1. Type of Well					N/A			
Oil Well Gas Well Other					8. Well Name and No. DUNCAN FEDERAL #12			
2. Name of Operator JALAPENO CORPORATION				9. Ai	9. API Well No. 30-005-64277			
FO BOX 1000			ıde area code)	10. F	10. Field and Pool or Exploratory Area			
ALBUQUERQUE, NM 87103 (505) 242-20			·

Duncan Federal #12

Jalapeno Corporation
After Plug & Abandon

Duncan Federal 12 30-005-64277 Ridgeway Arizona Oil Corp March 12, 2018 Conditions of Approval

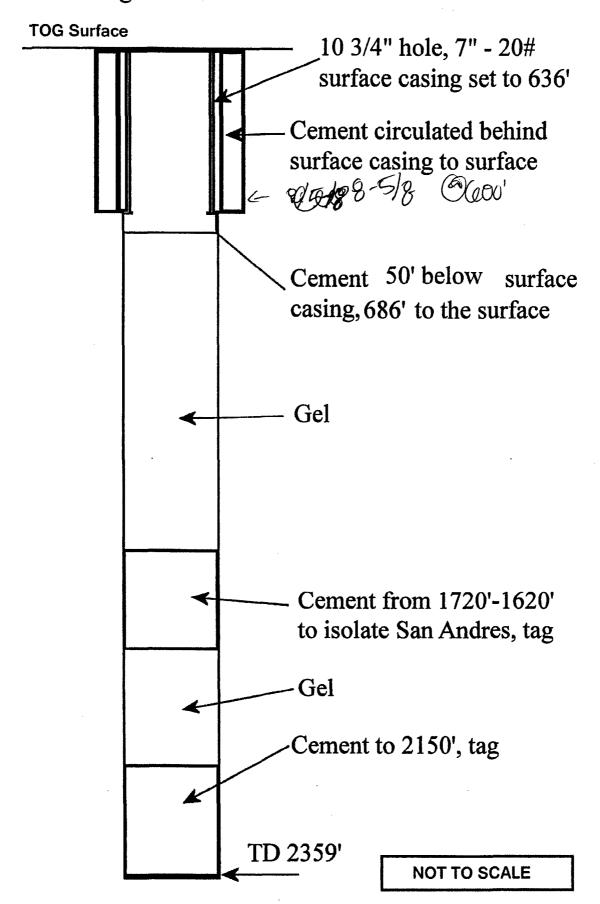
- 1. Operator shall set a Class C plug from 2,359'-2,150' as proposed. WOC and Tag as proposed.
- 2. Operator shall set a Class C plug from 1,720'-1,550' (plug must be 170' in length for this depth). WOC and tag as proposed.
- 3. Operator shall set a Class C plug from 686' to surface as proposed.
- 4. See Attached for general plugging stipulations.
